ADDENDUM NO. 1
TO THE
DRAWINGS AND SPECIFICATIONS
FOR THE
17TH Street Reconstruction

Issued From: The City of Bloomington
Planning and Transportation Department
Post Office Box 100
401 North Morton Street, Suite #130
Bloomington, Indiana 47402

Issue Date: January 24th, 2019

SCALE	BRIDGE FILE
1/4" = 1'-0"	N/A
	DESIGNATION
	N/A
SURVEY BOOK	SHEETS
N/A	3 of 100
CONTRACT	PROJECT
N/A	17TH STREET RECONSTRUCTION

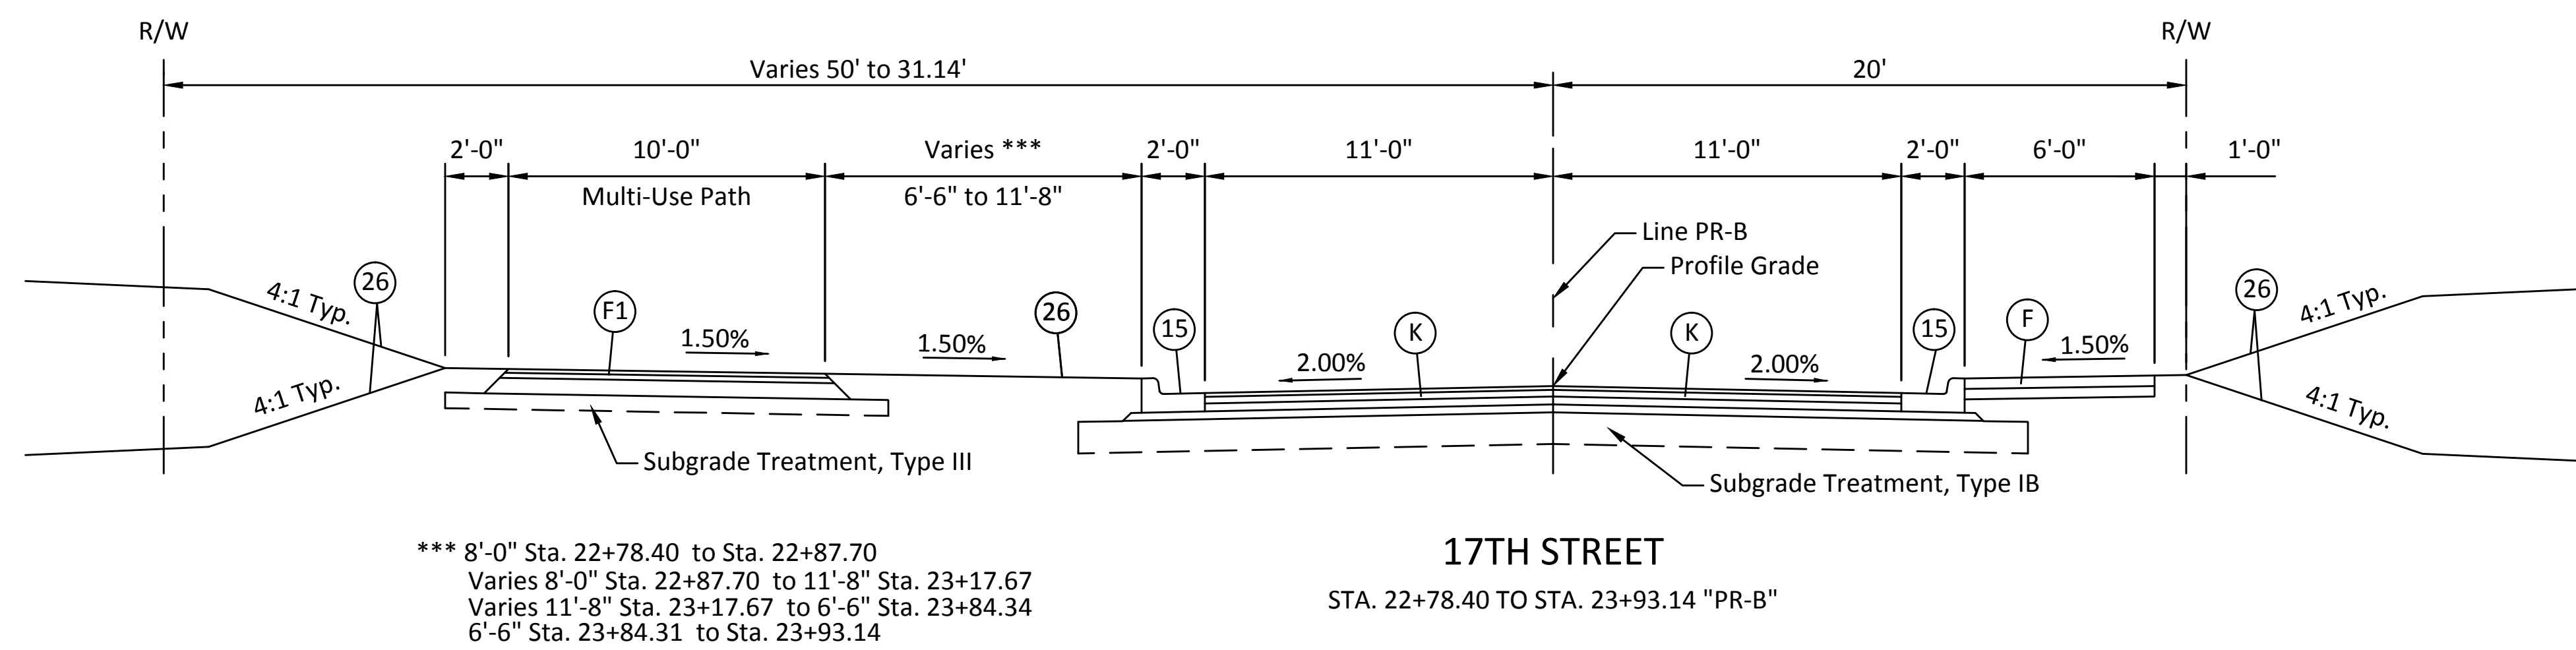
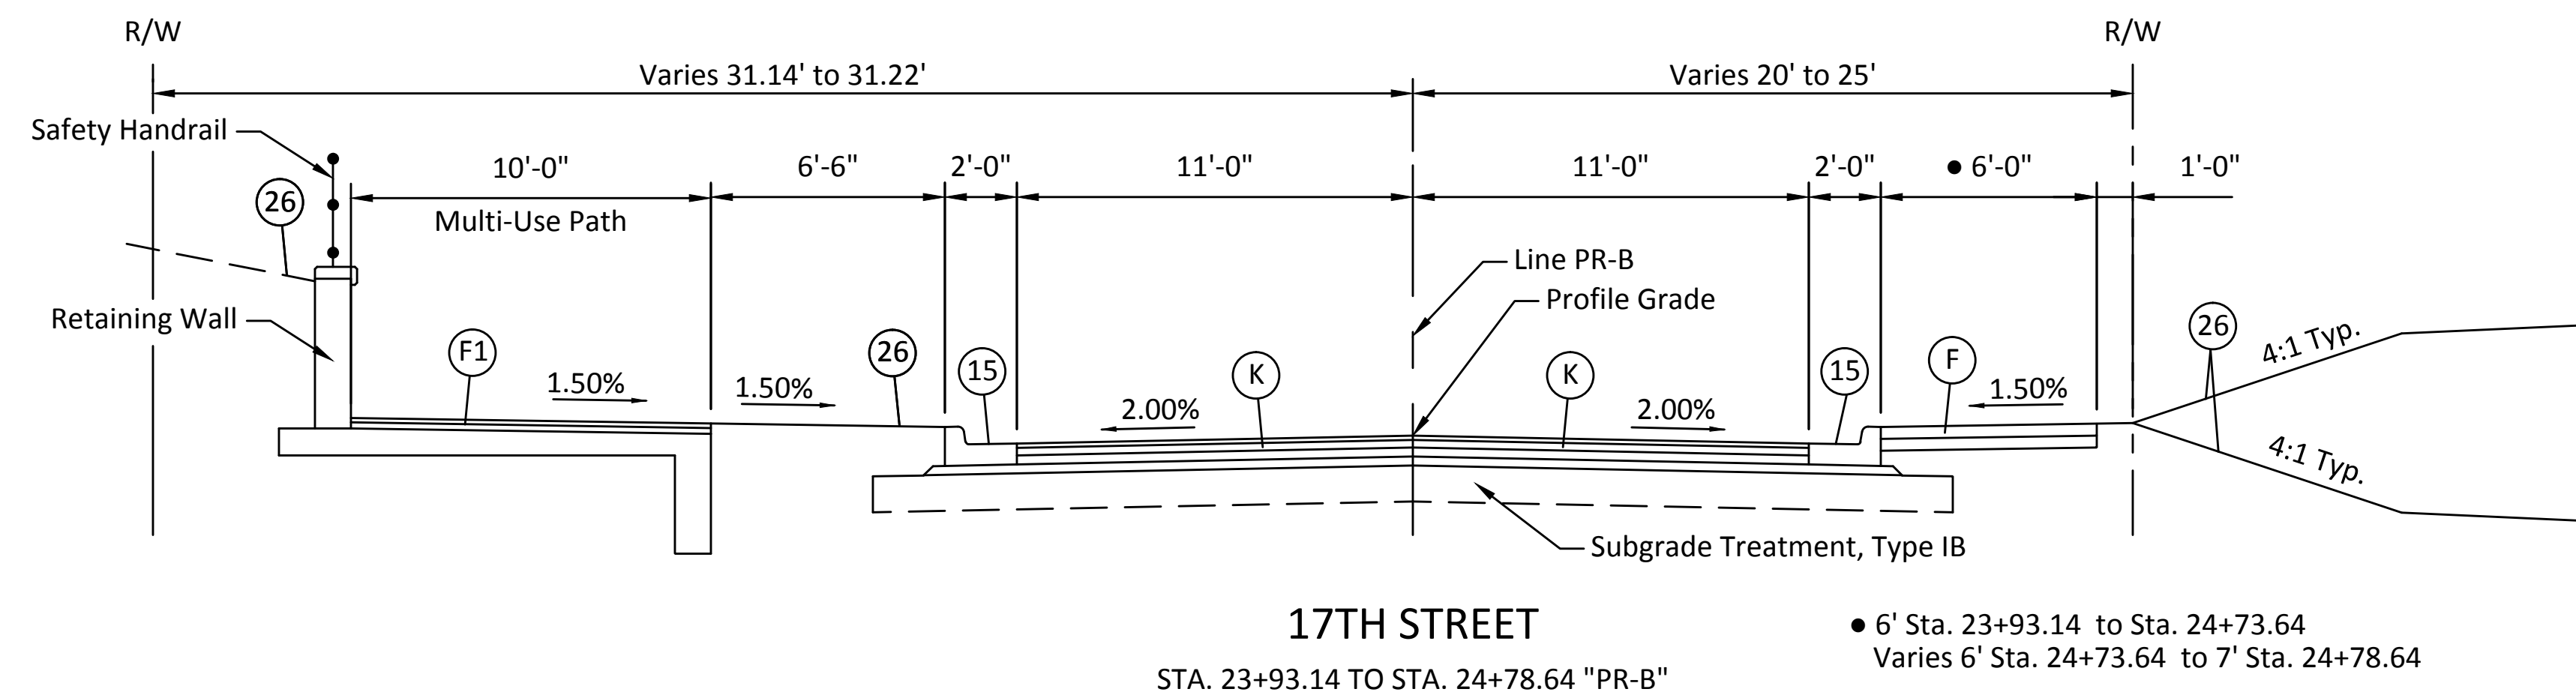
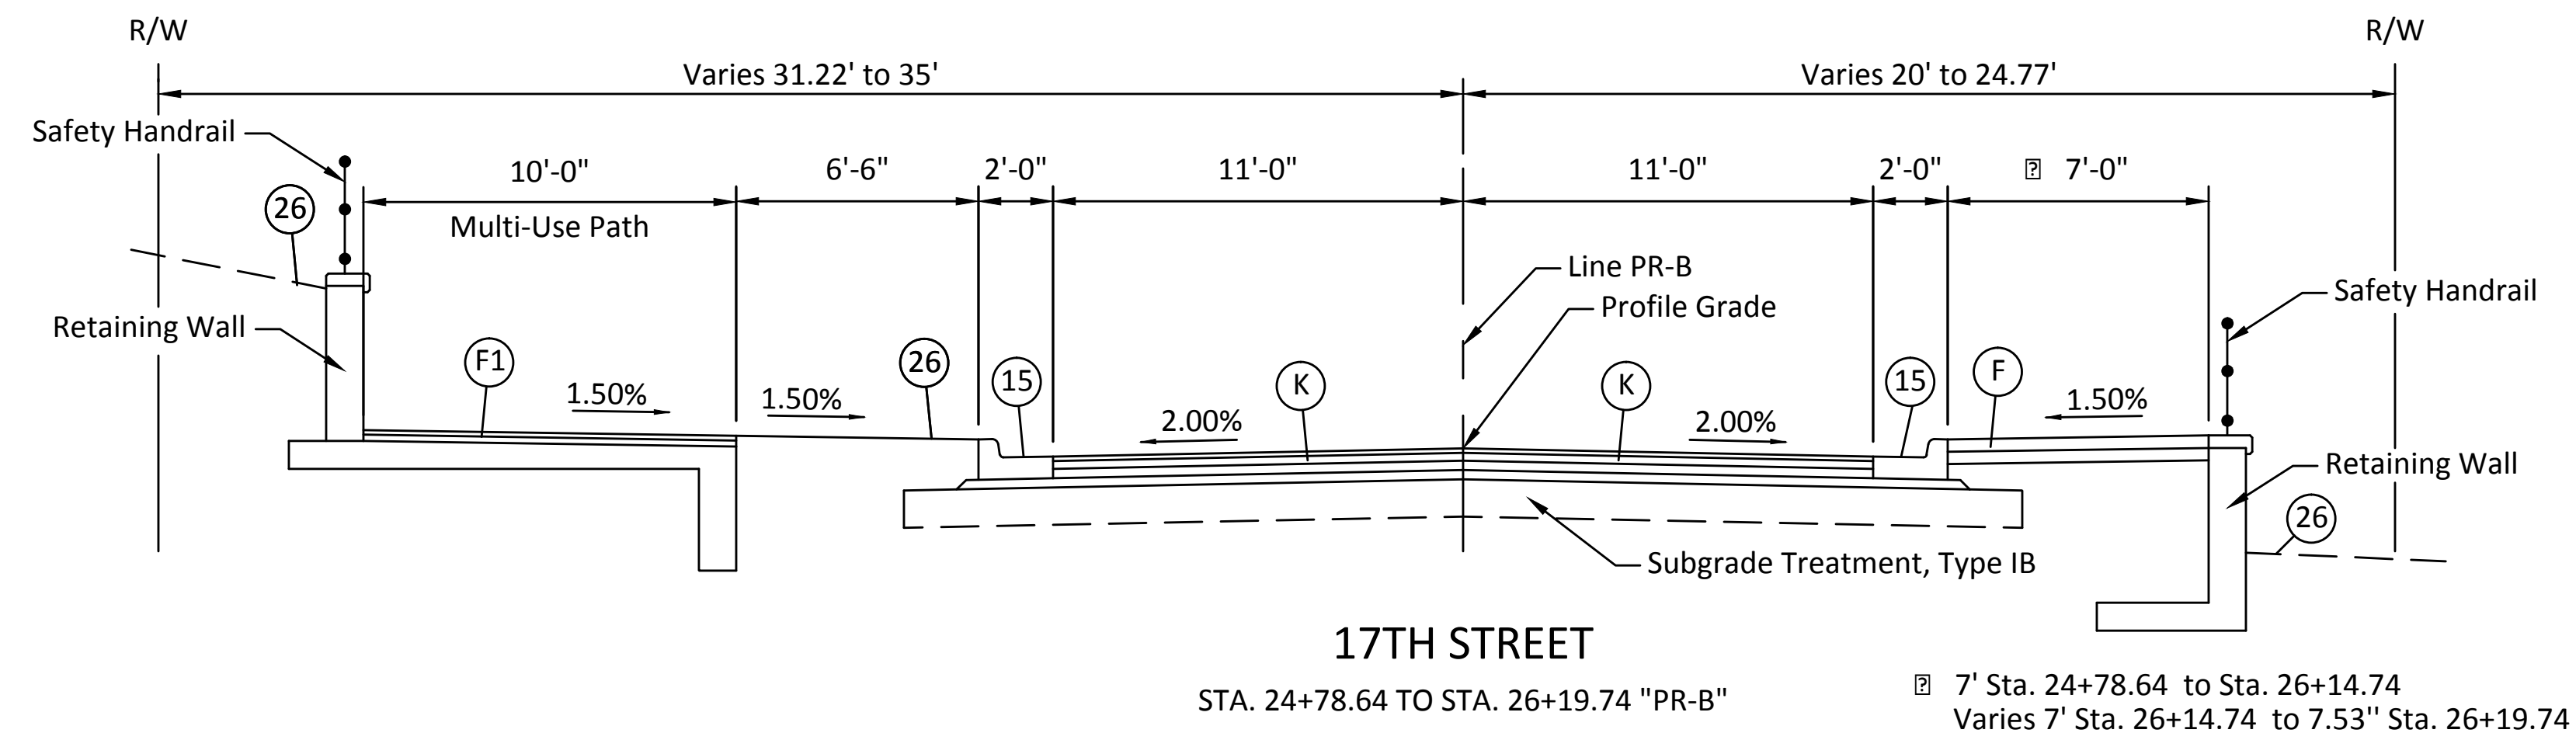
(Q) Will the city consider changing intermediate and surface asphalt courses to 2, 64 from 2, 70 type mix?

(A) Yes, the Legend Item K, sheets 2-6 have been revised. The surface and intermediate layers shall be 2, 64 type mix. Revised plan sheets and a revised "Proposal Schedule of Items" have been added per this addendum.

SCALE	BRIDGE FILE
1"=20'	N/A
	DESIGNATION
	N/A
SURVEY BOOK	SHEETS
N/A	17 of 100
CONTRACT	PROJECT
N/A	17TH STREET RECONSTRUCTION

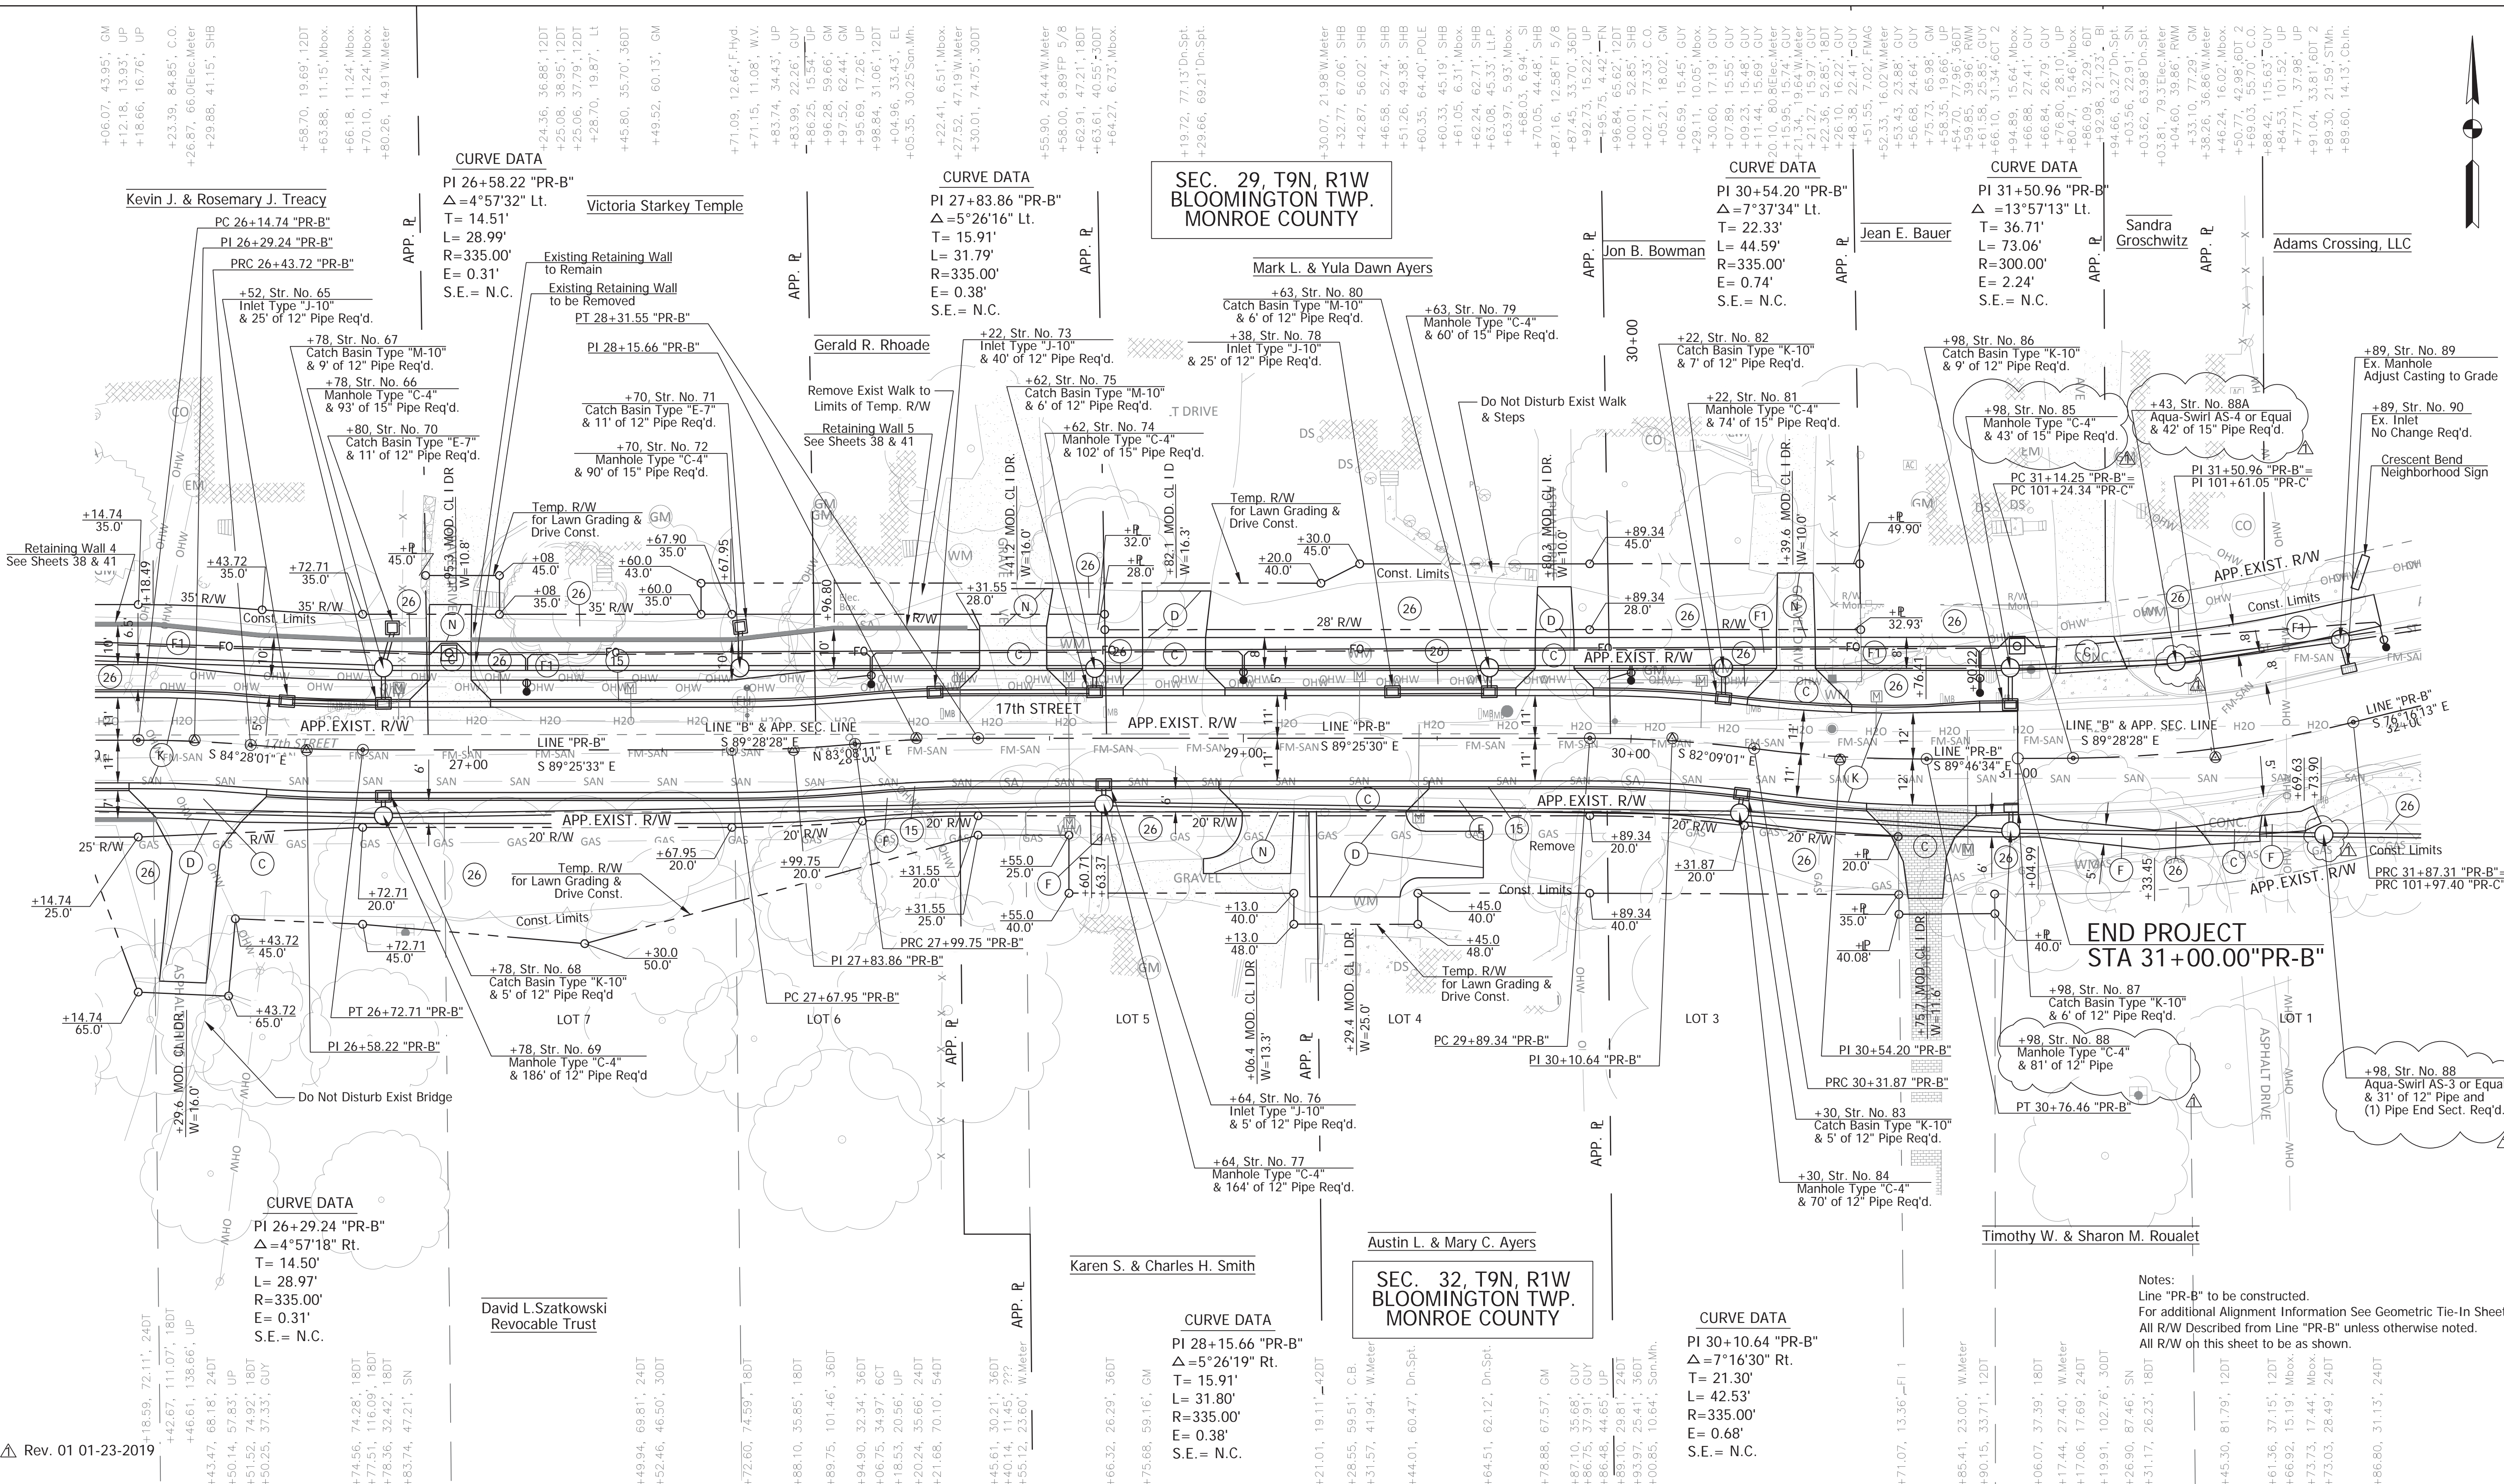
The Plan and Profile Details, sheets 17 & 18, and the Structure Data Table, Sheet 77, have been revised to add separate structures for the Aqua-Swirl structures at the east end of the project. Revised plan sheets and a revised "Proposal Schedule of Items" have been added per this addendum.

(Q) Some of the aqua-swirls are shown with more than one inlet. After talking with manufacturer this cannot be accomplished, there should be one inlet and one outlet?

(A) The Plan and Profile Details, sheets 17 & 18, and the Structure Data Table, Sheet 77, have been revised to add separate structures for the Aqua-Swirl structures at the east end of the project. Revised plan sheets and a revised "Proposal Schedule of Items" have been added per this addendum.
